Re: **Docket No. 507 – Application of Homeland Towers, LLC and Cellco Partnership d/b/a Verizon Wireless for a Certificate of Environmental Compatibility and Public Need for the Construction, Maintenance and Operation of a Wireless Telecommunications Facility at 222 Clintonville Road, North Branford, Connecticut**

**RESPONSES OF HOMELAND TOWERS, LLC AND
CELLCO PARTNERSHIP D/B/A VERIZON WIRELESS TO
CONNECTICUT SITING COUNCIL PRE-HEARING INTERROGATORIES, SET ONE**

**SITE "CT021 – NORTH BRANFORD"
222 CLINTONVILLE ROAD
NORTHFORD, CT**

CT SITING COUNCIL DOCKET NO. 507
RESPONSE TO INTERROGATORY 30
CT021
222 CLINTONVILLE ROAD
NORTHFORD, CONNECTICUT

Figure A1
LAND COVER VIEWSHED MAP - 2 MILE RADIUS
Revised Tower Location

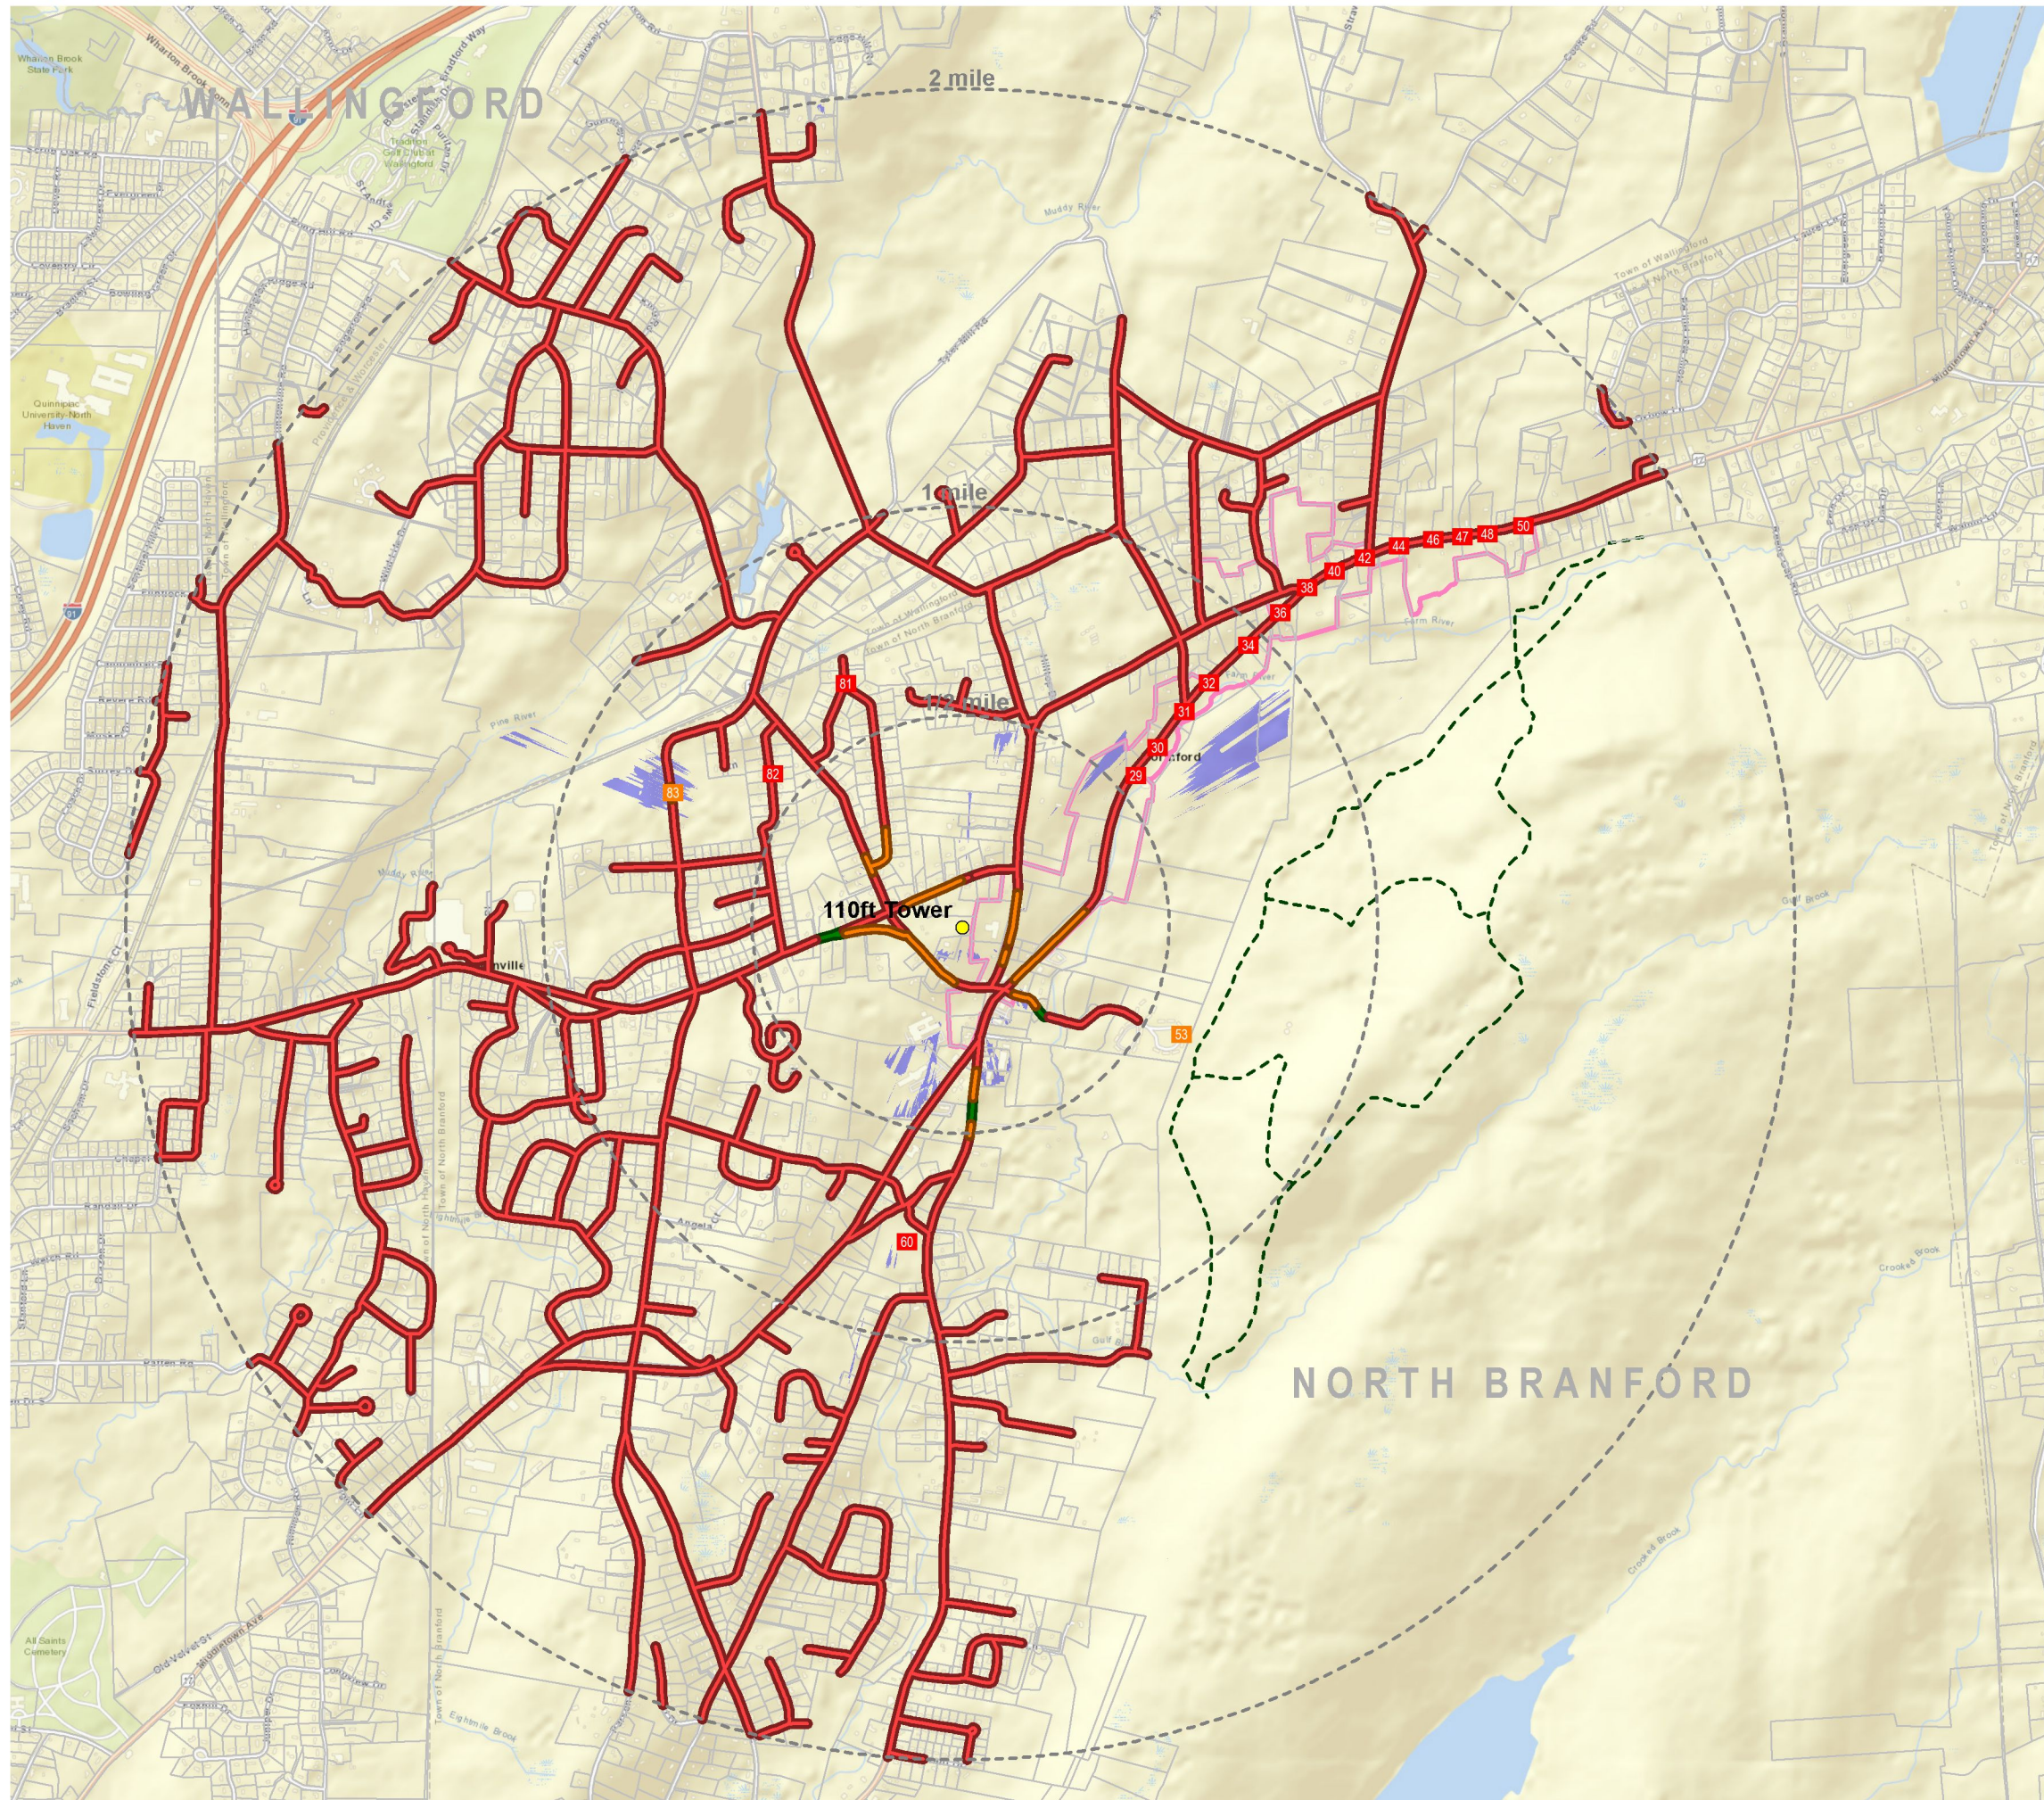
- a. would the shift of the tower location 45 feet to the south affect the areas of visibility shown on the viewshed map that was prepared for the initial site?
- b. what would be the expected visibility of the proposed tower from the open areas of the properties to the south and southeast of the site?
- c. the estimates of visibility on p. 9- *Viewshed Analysis Summary*- do not match the estimates provided on p. 10 - *Conclusion*. Clarify.
- d. estimate the number of residences that would have seasonal and/or year-round views within 0.5 miles of the proposed facility.
- e. Where is the nearest publicly accessible recreational area from the proposed tower? Identify the recreation area and describe the visibility from this area.

- a. **would the shift of the tower location 45 feet to the south affect the areas of visibility shown on the viewshed map that was prepared for the initial site?**

The shift of the tower location 45 feet to the south has no meaningful effect on the area of visibility shown on the viewshed map (*see* VRA Figures A1 and A2). Attached are revised viewshed maps illustrating the area of potential tower visibility at the currently proposed location.

The following table compares the total viewshed area for the original location and the currently proposed location:

Area within 2-mile radius		Area within ½-mile radius	
	Acres	Percent	Acres	Percent
Original Tower Position	39	0.49%	10	2.0%
Shifted Tower Position	43	0.54%	13	2.6%
Change	+4	+0.05%	+3	+.03%

PHOTO LOG

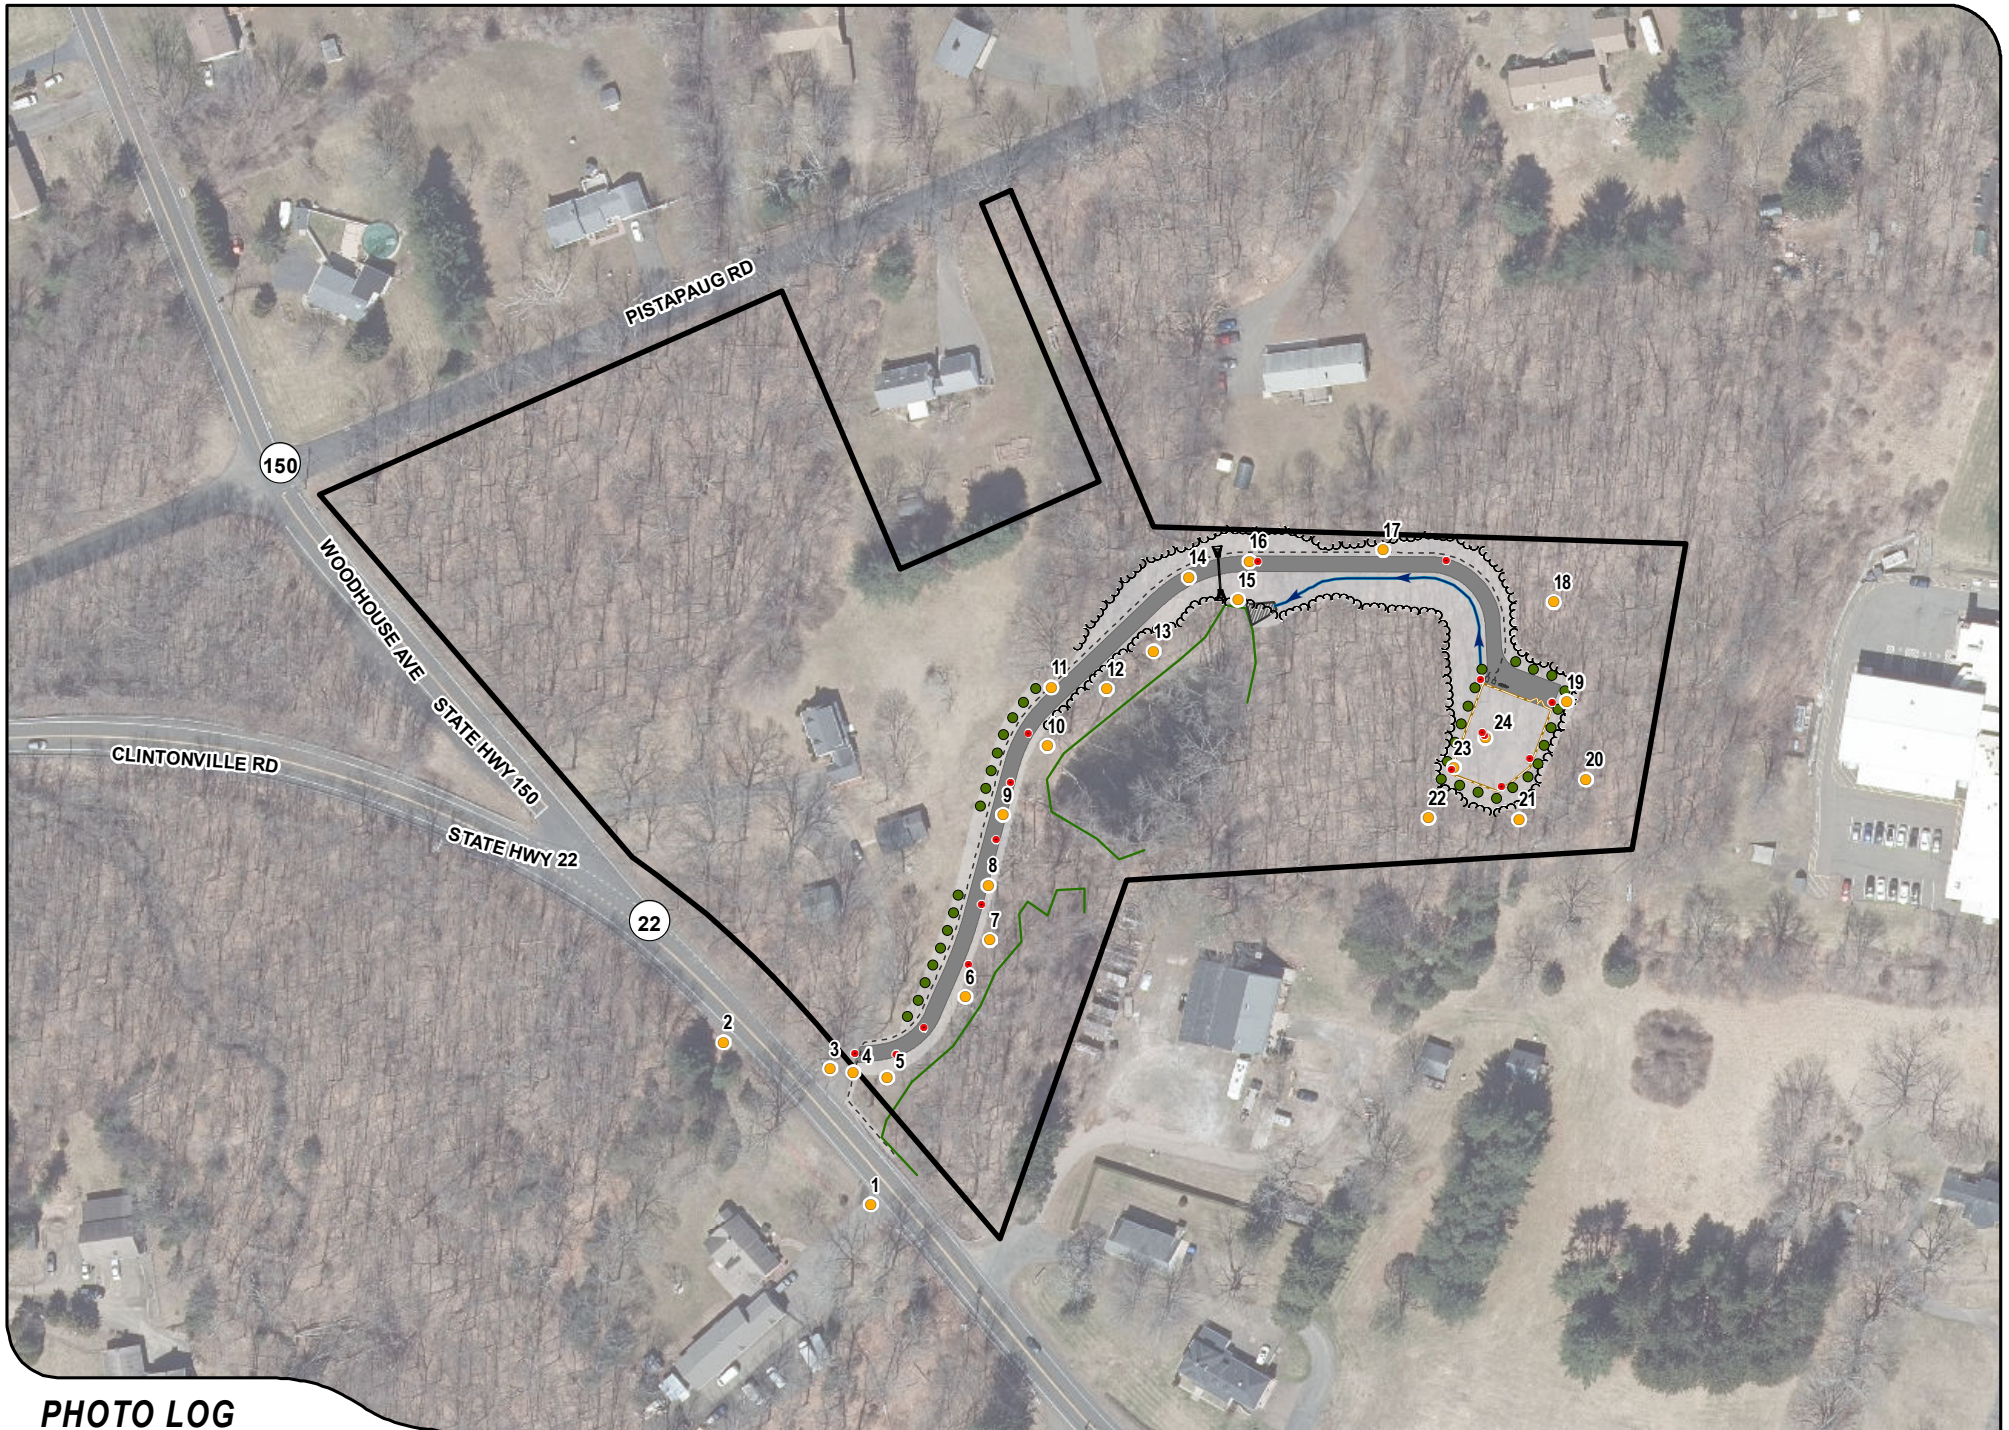
Submit photographic site documentation with notations linked to the site plans or a detailed aerial image that identifies locations of site-specific and representative site features. The submission should include photographs of the site from public road(s) or publicly accessible area(s) as well as Site-specific locations depicting site features including, but not necessarily limited to, the following locations as applicable:

A photolog graphic must accompany the submission, using a site plan or a detailed aerial image, depicting each numbered photograph for reference. For each photo, indicate the photo location number and viewpoint direction, and clearly identify the locations of site specific and representative site features shown (e.g., physical staking/flagging or other means of marking the subject area).

See the attached Remote Field Review.
